# UNITED STATES PATENT AND TRADEMARK OFFICE

## Office Action Summary

10/643,862

## **DETAILED ACTION**

Fig. 1a

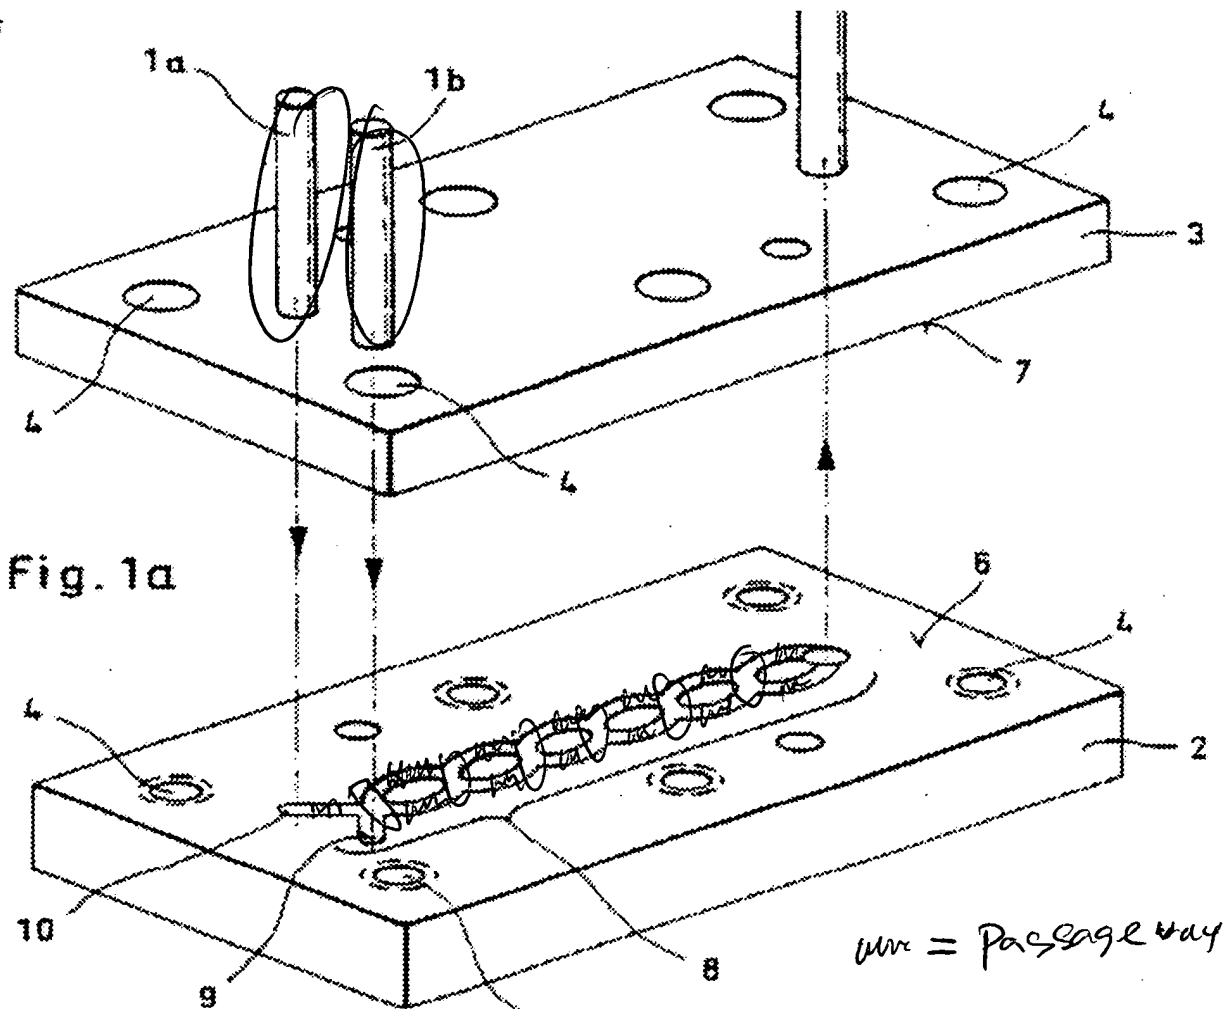
The Koop reference discloses an apparatus and method of use for mixing fluids including two inlets for a 1<sup>st</sup> and 2<sup>nd</sup> fluid to be fed into a 1<sup>st</sup> chamber at the intersection of 9,10, a second chamber through seventh at the intersection of the sinusoidal loops which are microchannel capillary passageways along the portion 8, see figure 1, which ends at an outlet chamber at 5 for further processing, whereby each loop side may be deemed as separated passageways.

MARKUP  
 TGS 1723

19 10  
 16 9

unc = passage way

O = chambers

9. Applicant argues that the Koop et al reference "containers no fist and second chambers connected through one or more separated capillary passageways" , see applicant's remarks page 10. In response, see the intervening chambers and connected passageways as discussed above in paragraph 4, and the figure mark up above.
